## The Enclave at Stonebridge At Meridian Ranch

Final Landscape Plan

PCD# PUDSP-18-003

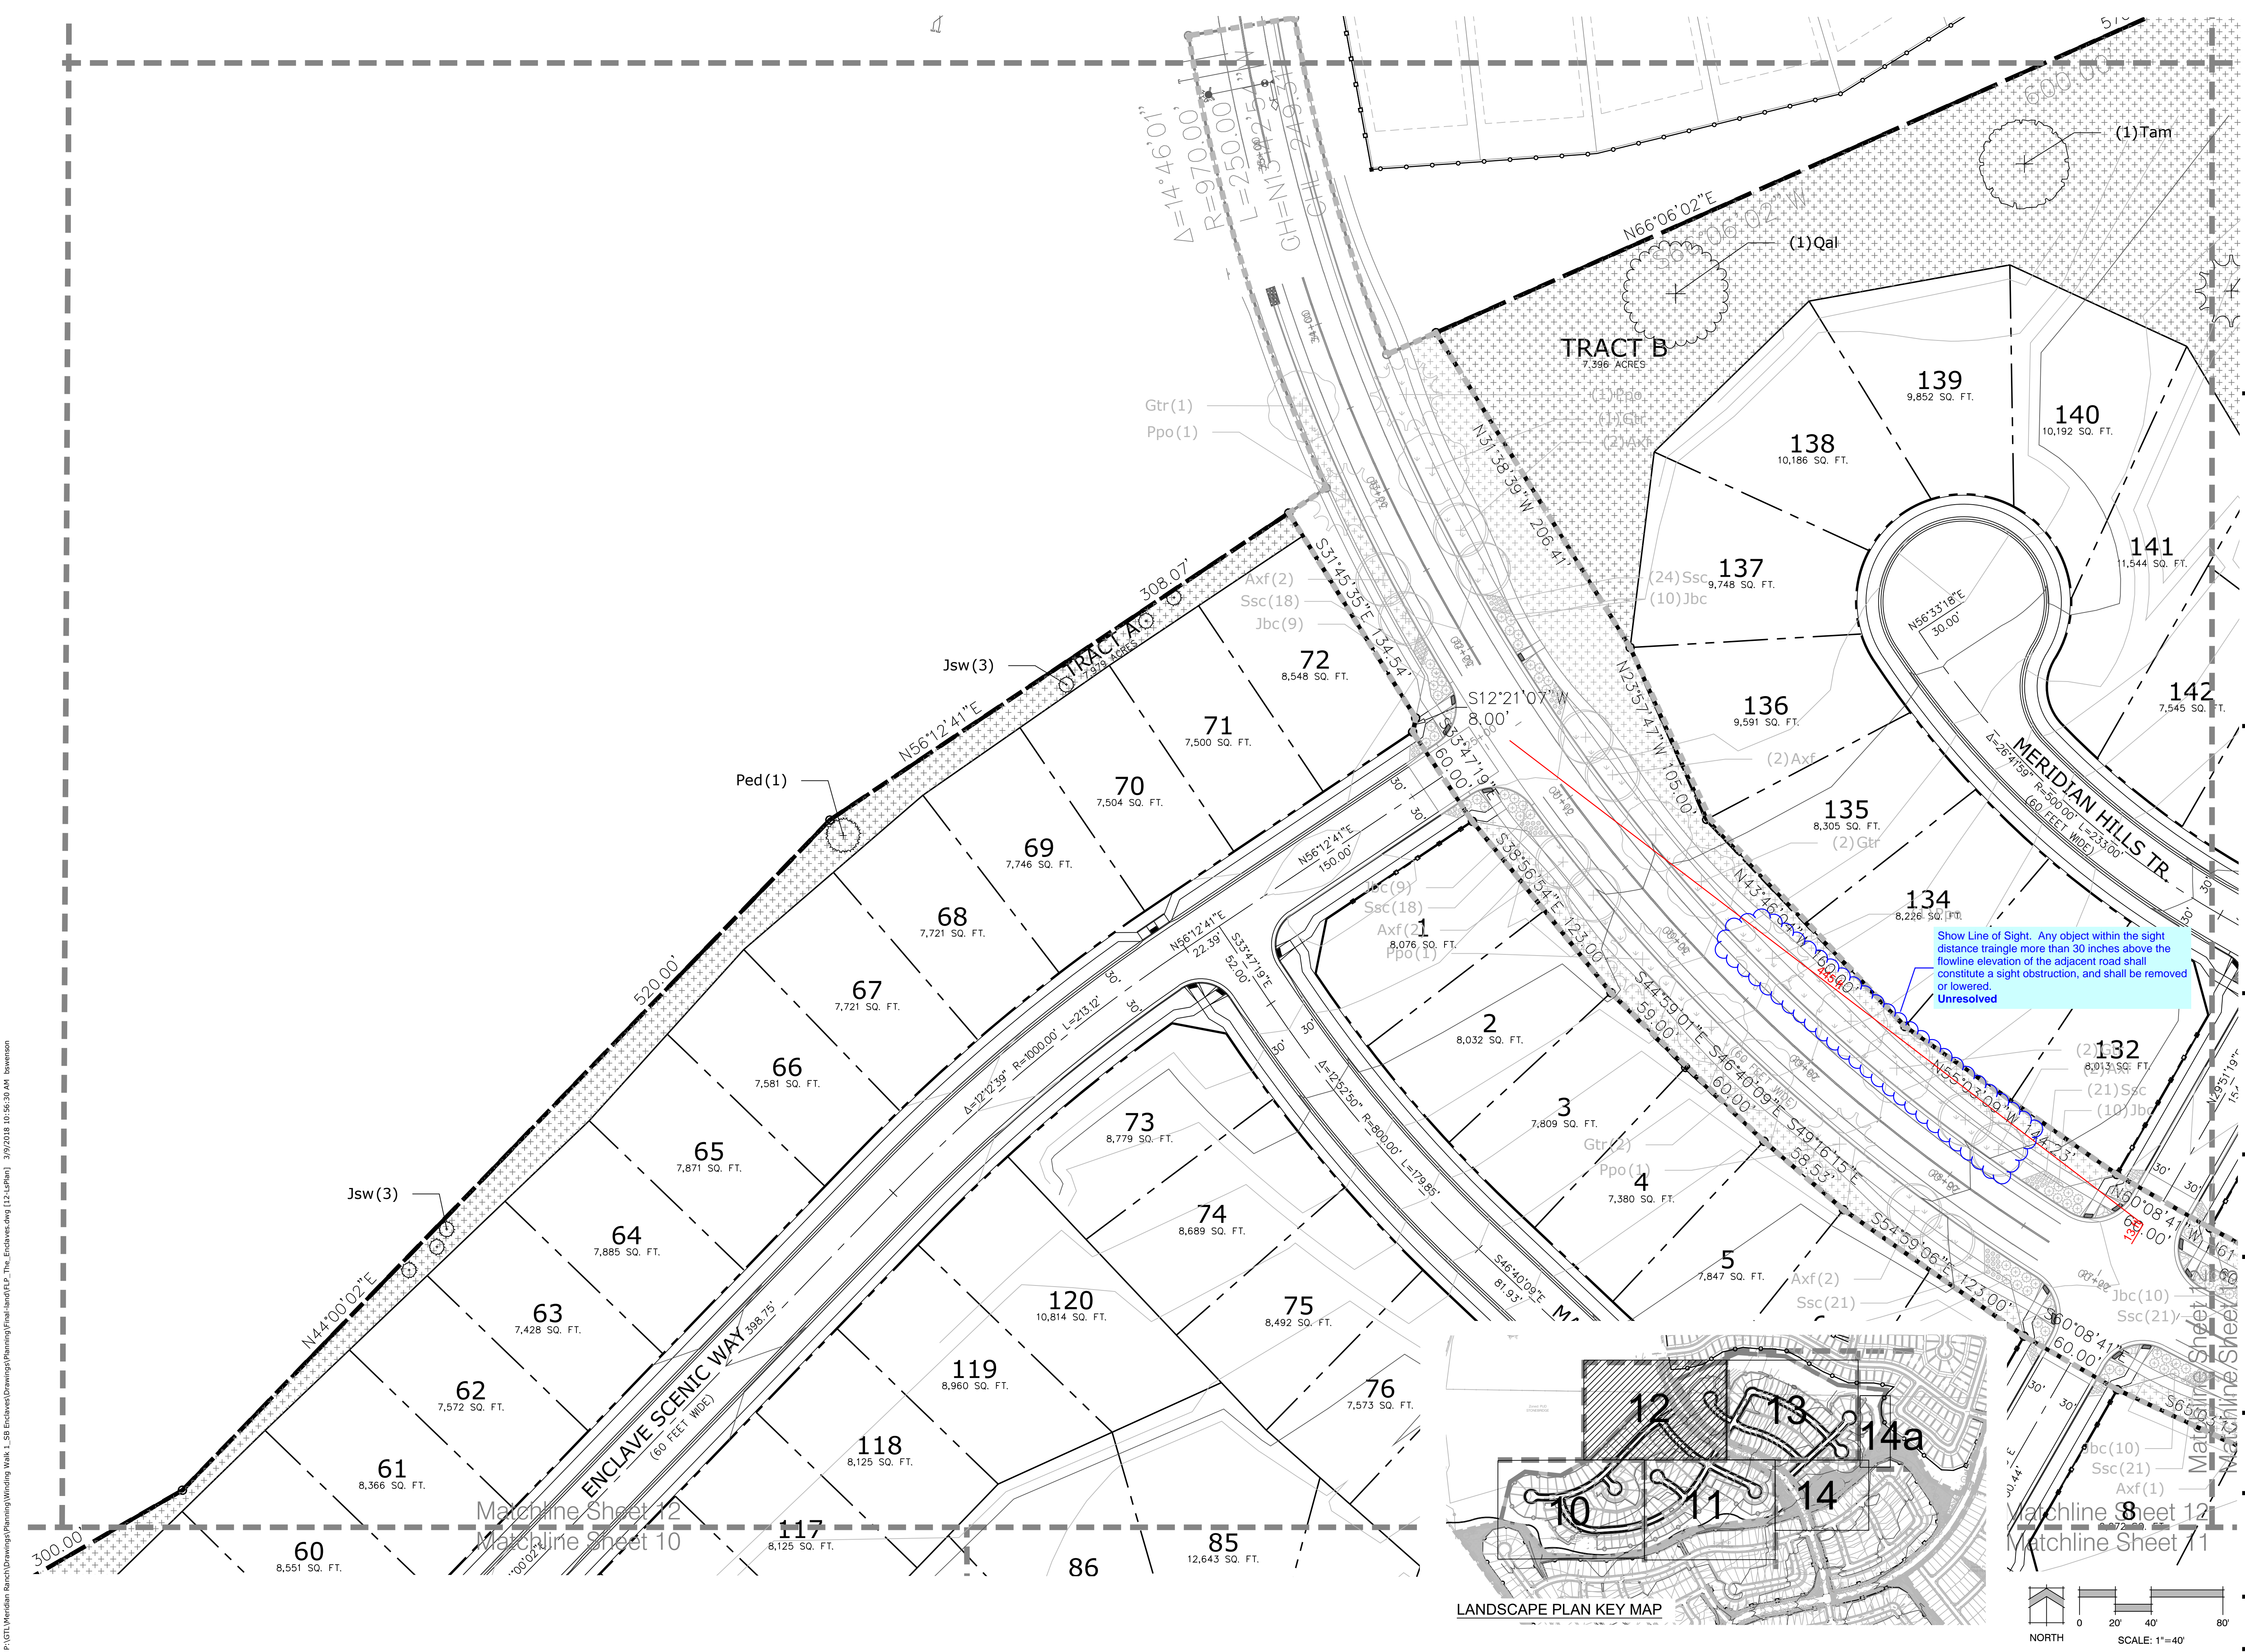
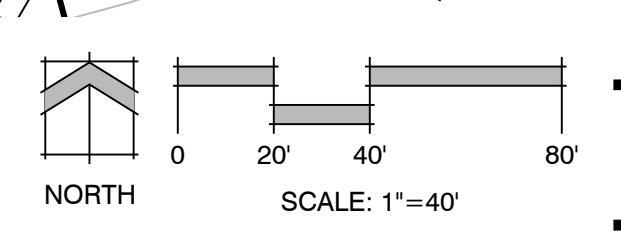
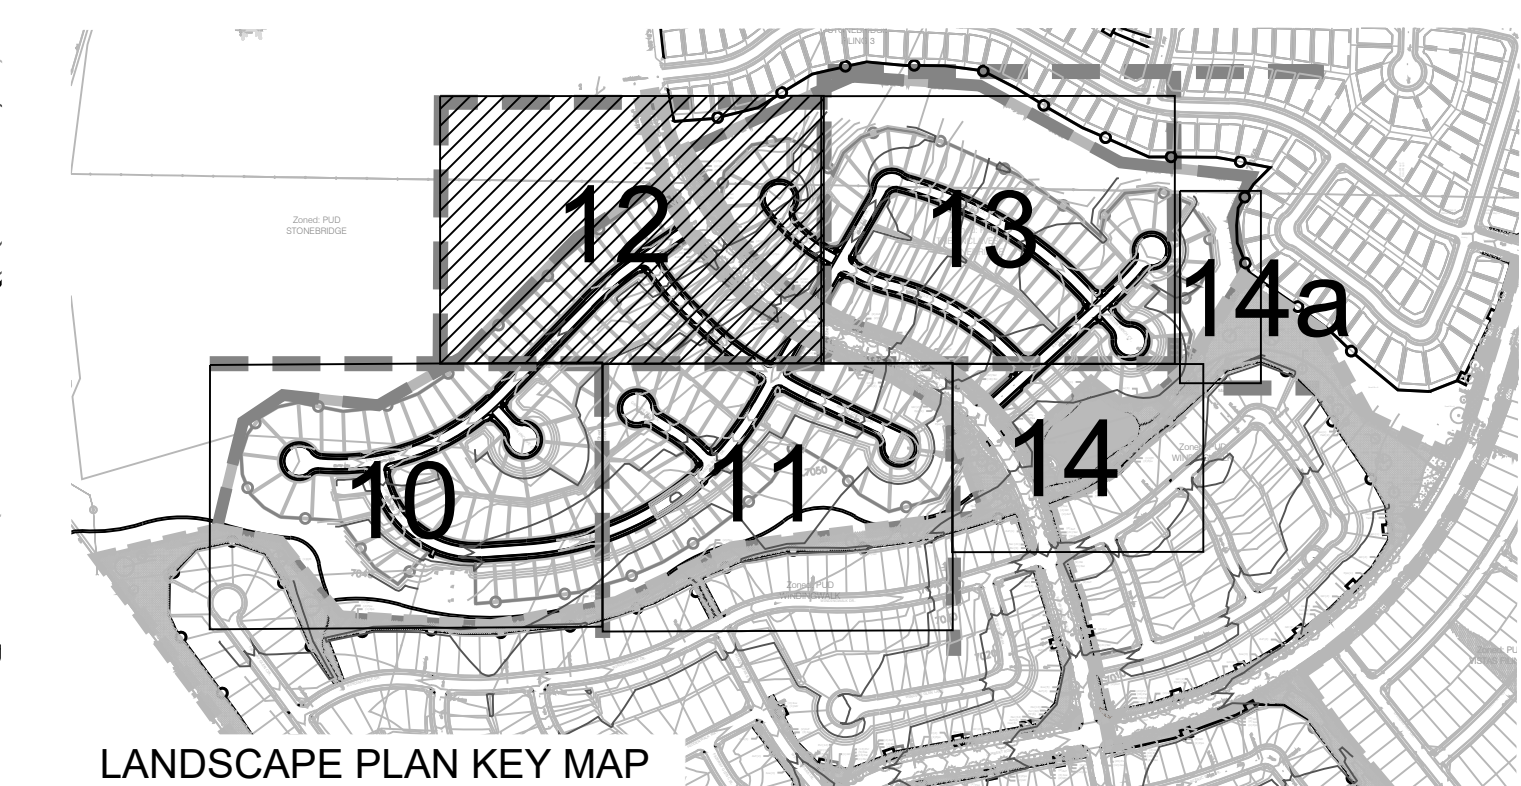
Show Line of Sight. Any object within the sight distance triangle more than 30 inches above the flowing elevation of the adjacent road shall constitute a sight obstruction, and shall be removed or lowered.  
**Unresolved**
